SUNDRY NOTICES AND REPORTS ON WELLS
*Do not use this form for proposals to drill or to re-enter an
abandoned well. Use Form 3160-3 (APD) for such proposals.*

8. Well Name and No.
ATALAYA FEDERAL #3

TESTING CASING TO 580 PSI FOR 30 MINS. PAUL SCHULTZ WITH THE BLM WITNESSED.
REQUEST TA STATUS

Unit Name: Atalaya #3 Operator: [Signature]
 Apt. #: 3001531063 T-120
 Leche #: 265-282108
 Date of Recorder Calibration: 01/20/13
 Testing Co.: Basic
 Date of Mechanical Integrity Test: 9/17/2013
 Operator Witness: [Signature]
 R.L.M. Witness: [Signature]

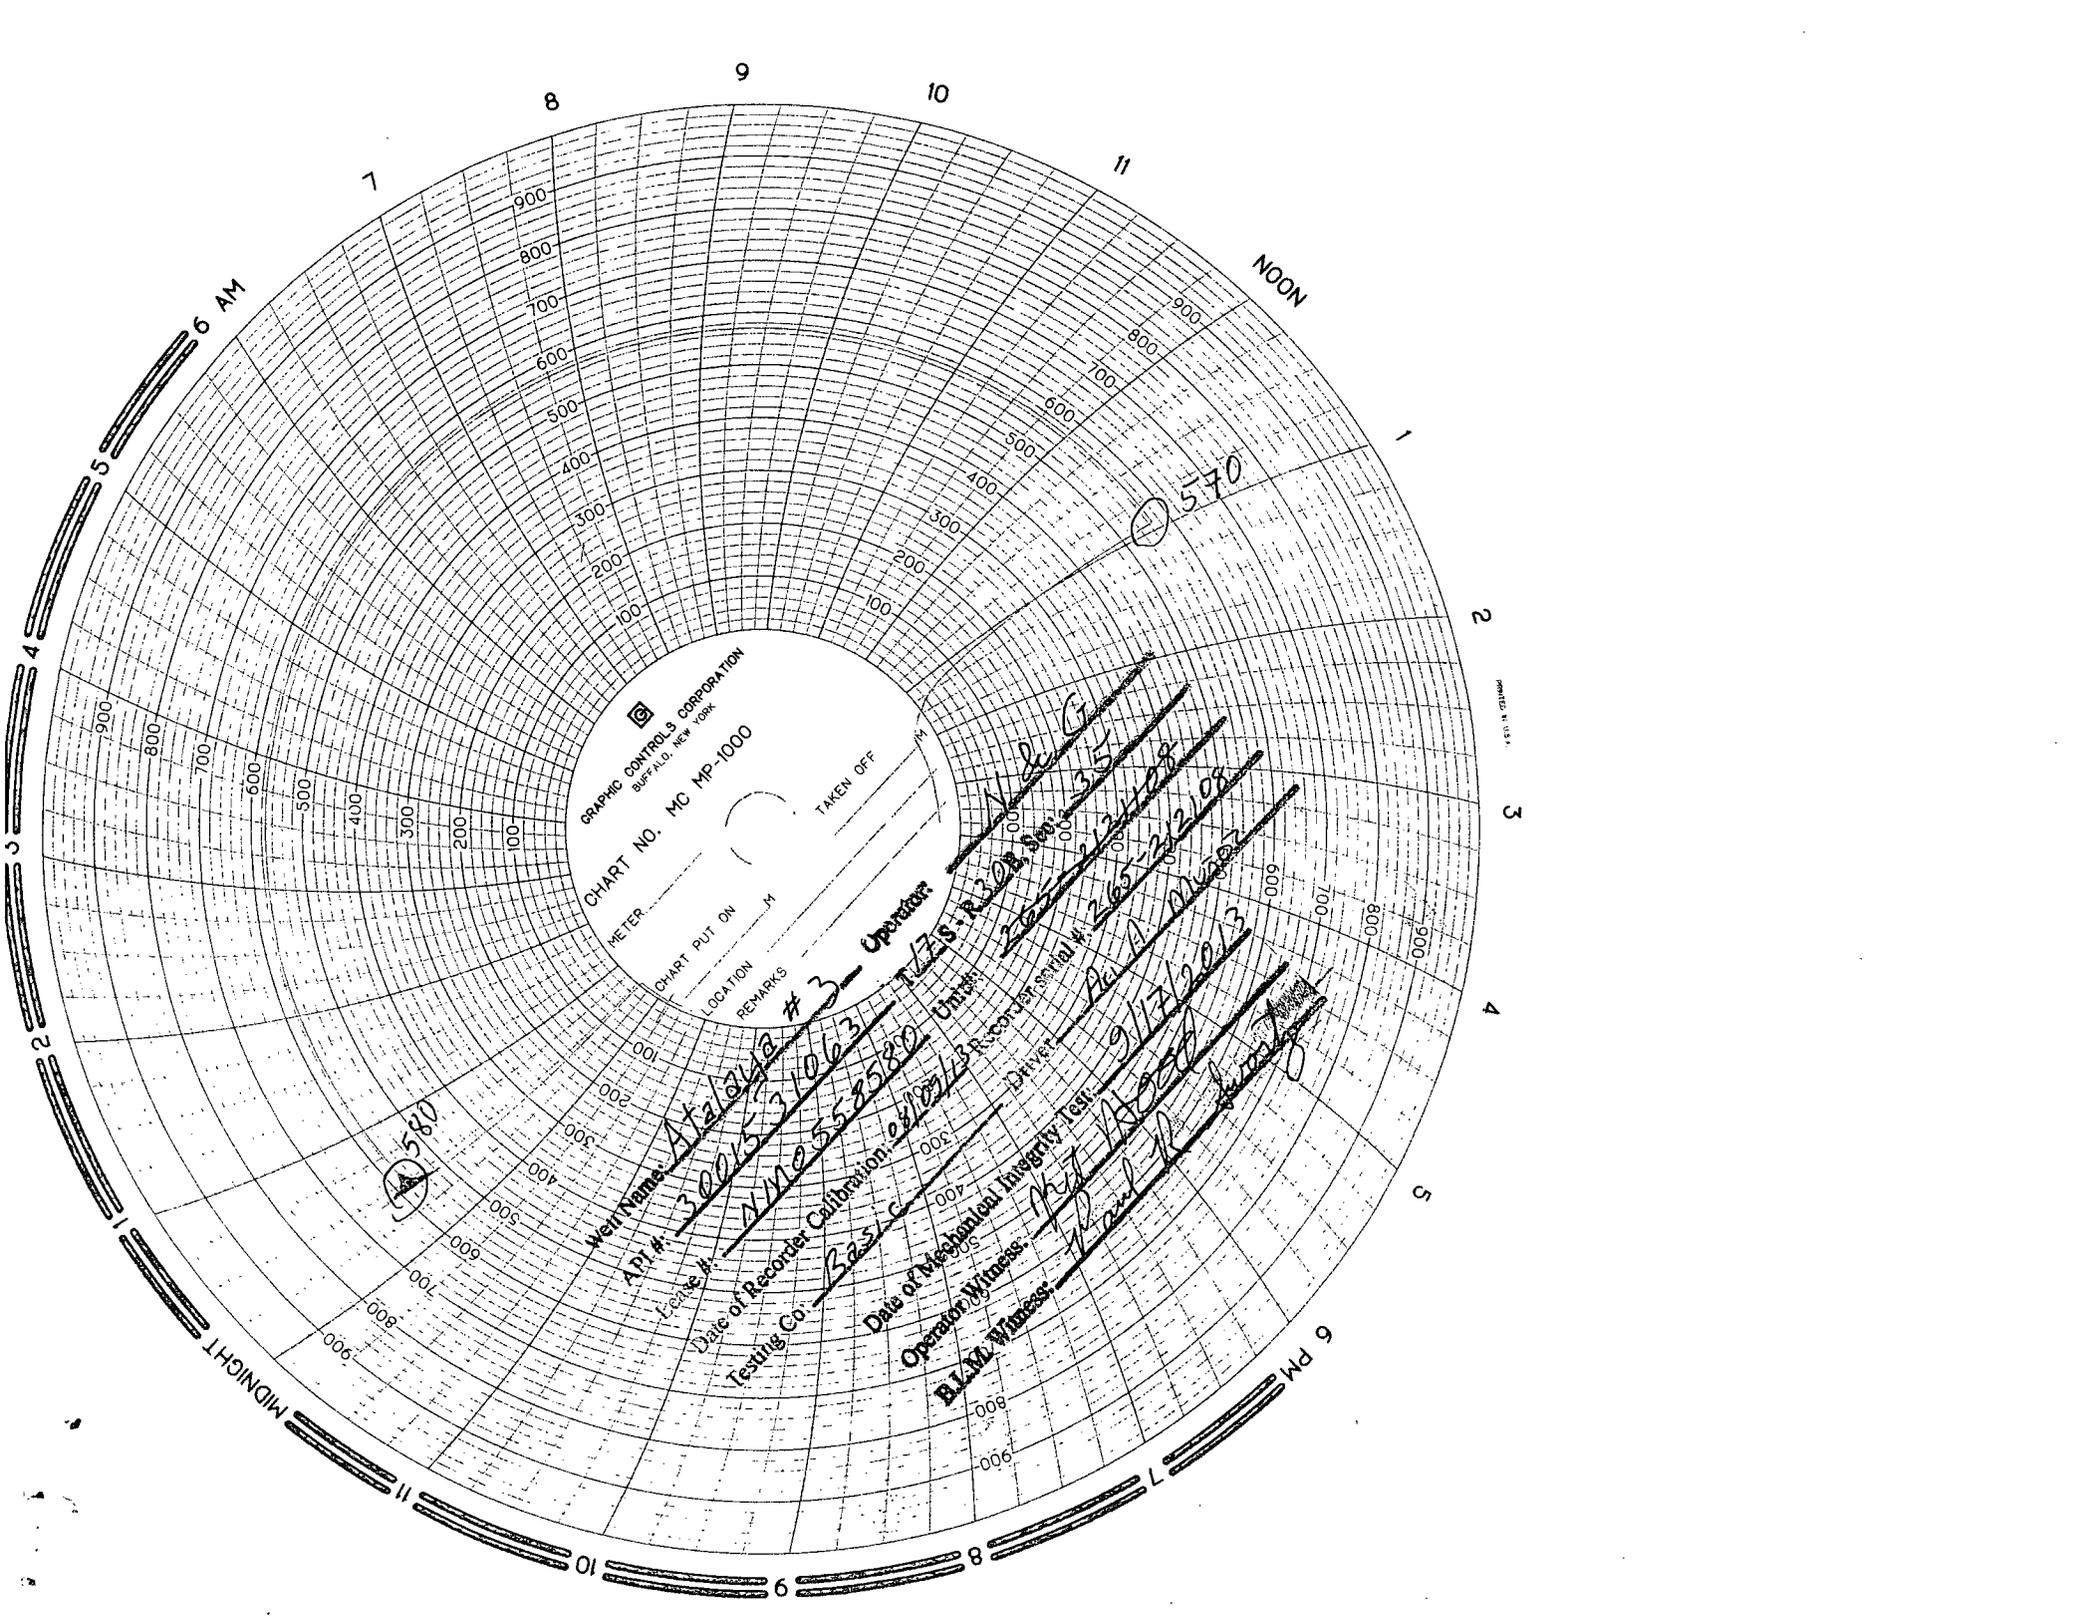
DENIED

WITHDRAWN, REJECTED, OR DENIED

See Attached
JDS

1. **Submits a subsequent Sundry Notice** (Form 3160-5) requesting TA approval **with well bore diagram** with all perforations and CIBP's and tops of cement on CIBP's.
2. Describes the temporary abandonment procedure.
3. Attaches a clear copy or the original of the pressure test chart.
4. Give justification to allow well to be place in TA status and plan for future use of well with time frame that well will be place back on line or plans to P&A well will be submitted.
